SITE SUPPLEMENTAL INSTRUCTION

PROJECT: Forestside Estates
Attmar & Palleschi Drive
Brampton, ON

SITE SI NO. M-2

PURPOSE: To revise mechanical layout to suit architectural SI A-01 and City comments.

GROUND FLOOR TYPICAL SUITE LAYOUT TYPE 2A4 & 2A2

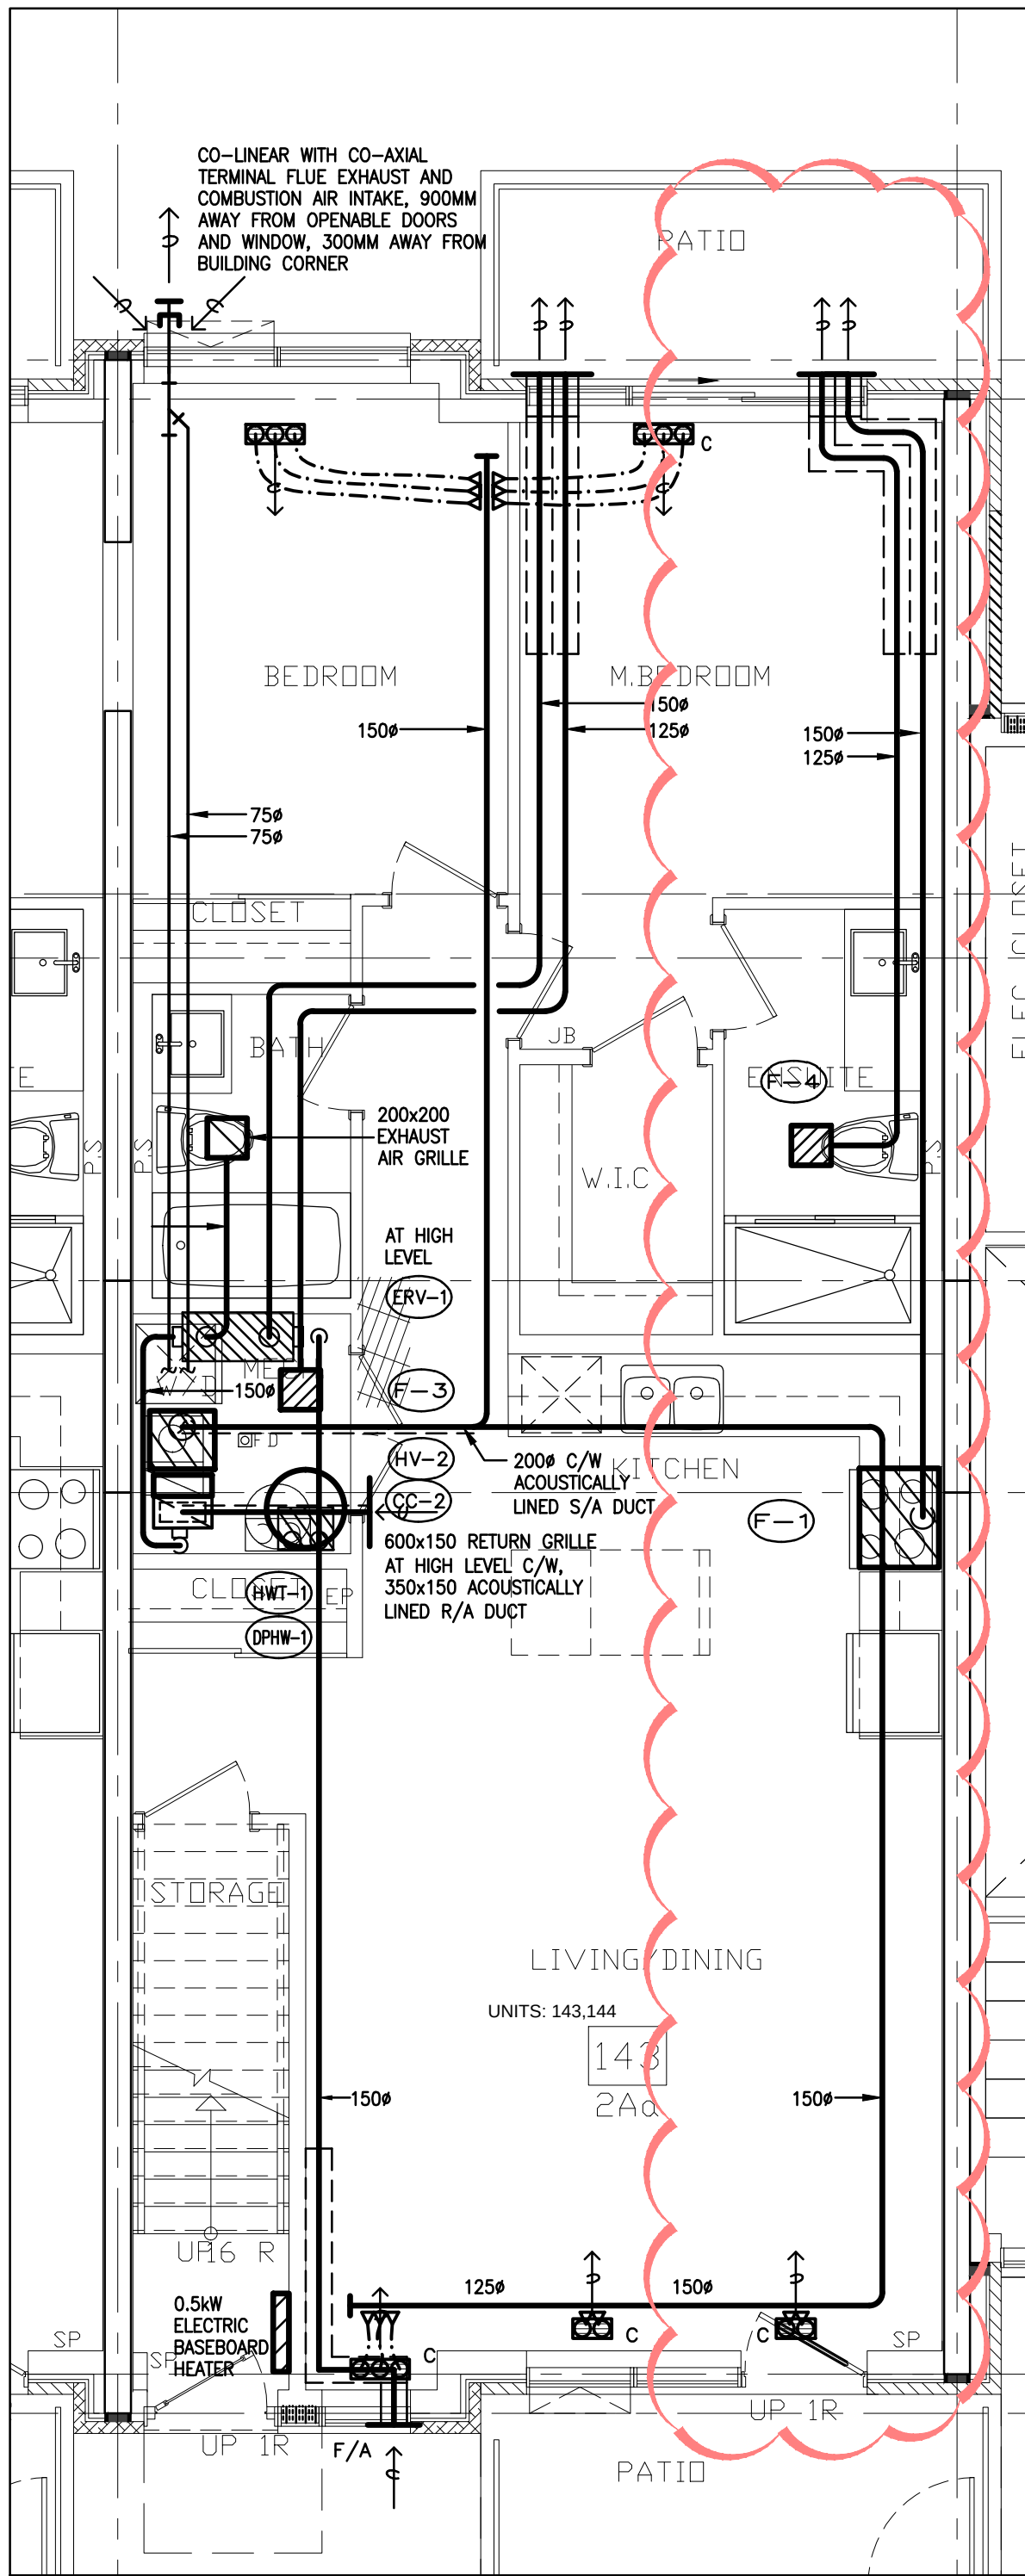
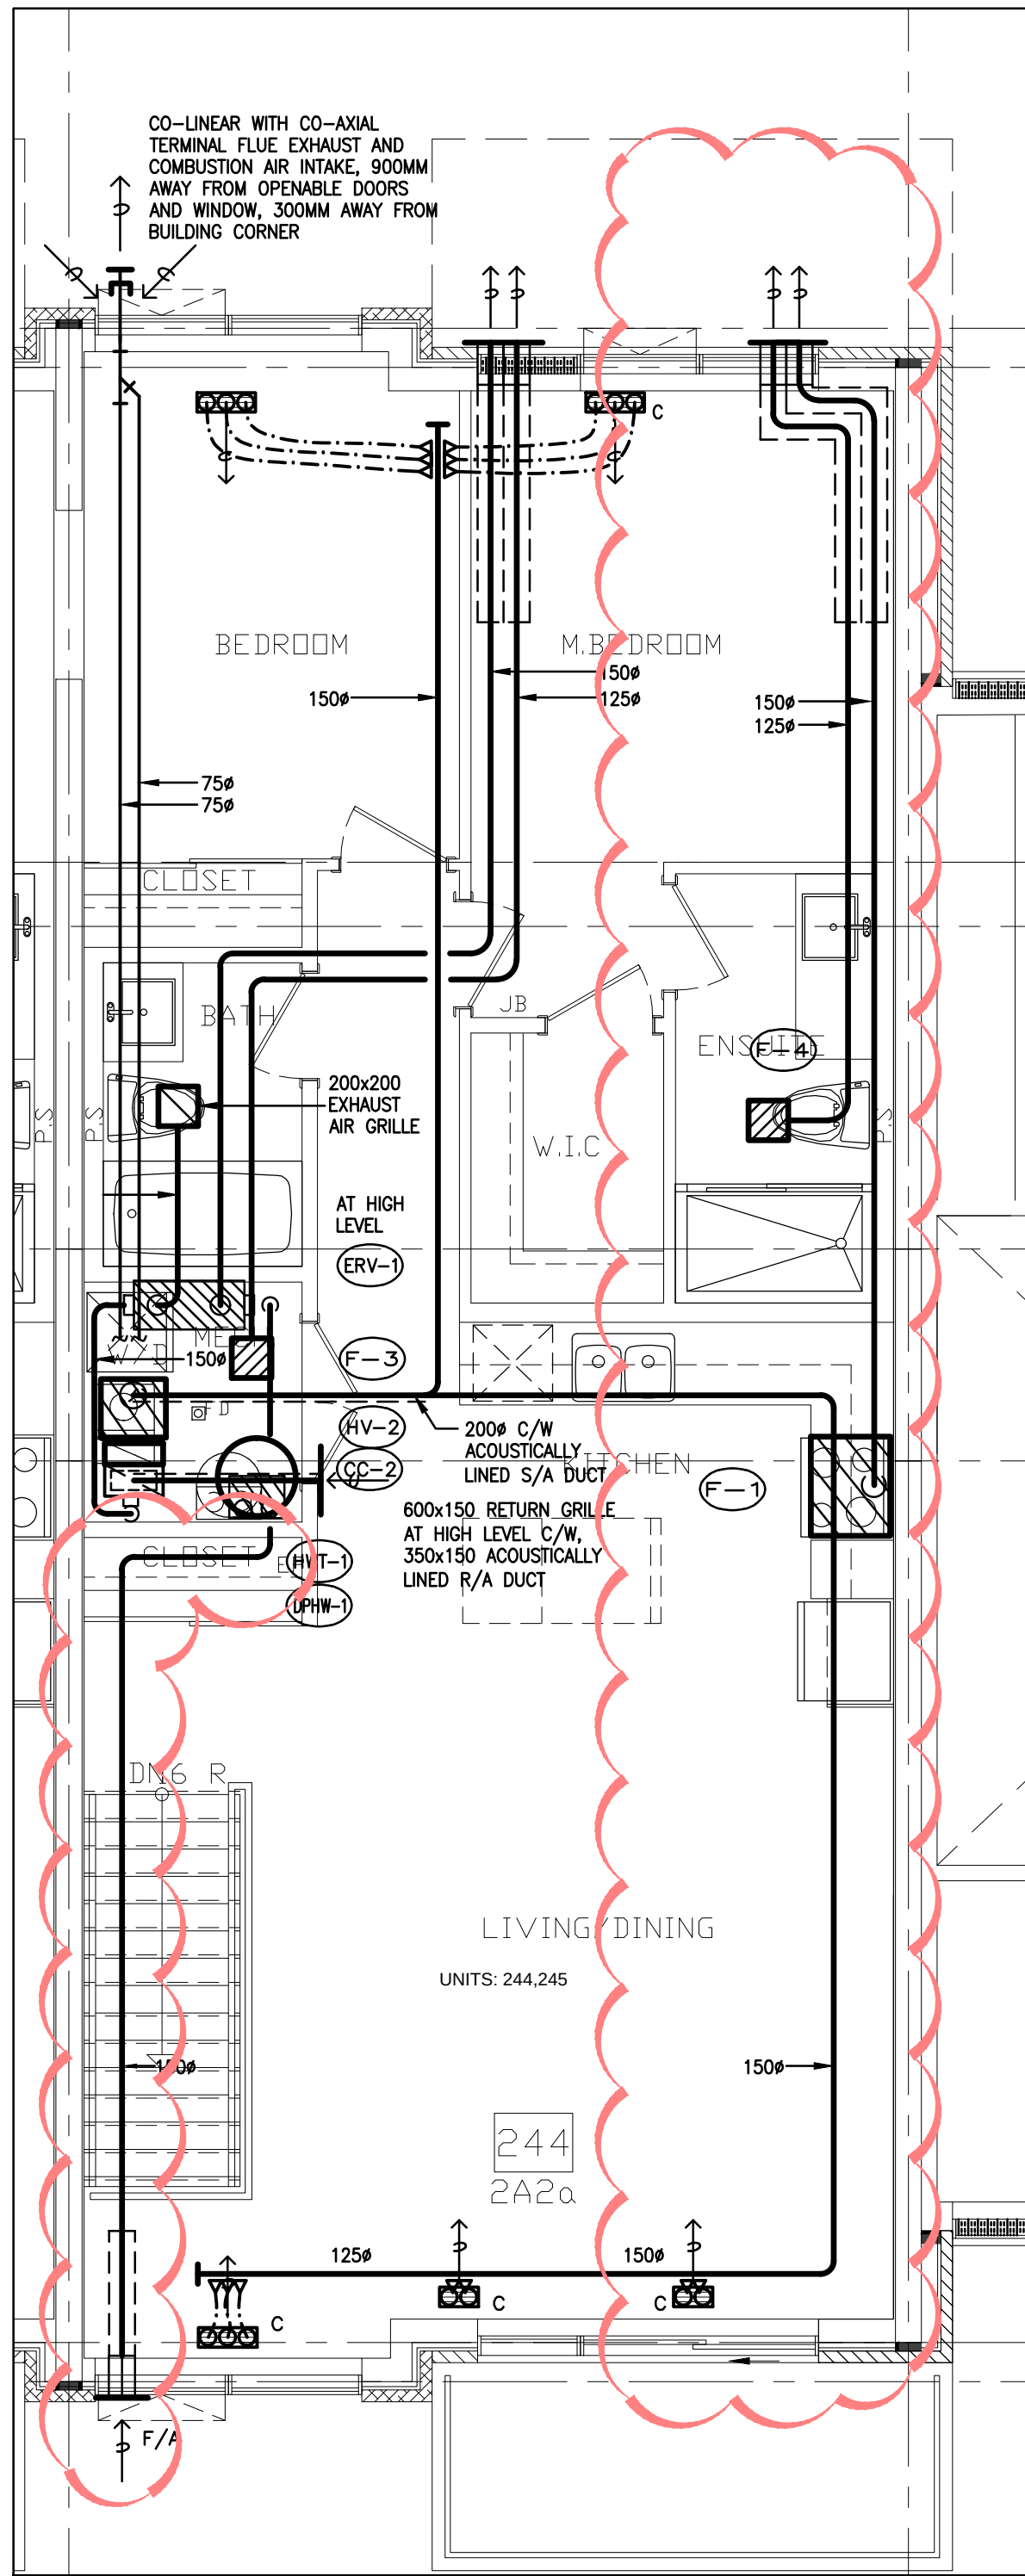
7.0 Reference Drawing M-45,M-46,M-47 (Typical Units - Mechanical) Issued

7.1 Added: Typical suite layout 2A1-R,2A-R and 2Aa-R.

7.2 Revised: Typical suite 2A,2A1,2Aa ,2Ab, 2A4,2A2,2A3,2A2a kitchen exhaust location according to code requirements.
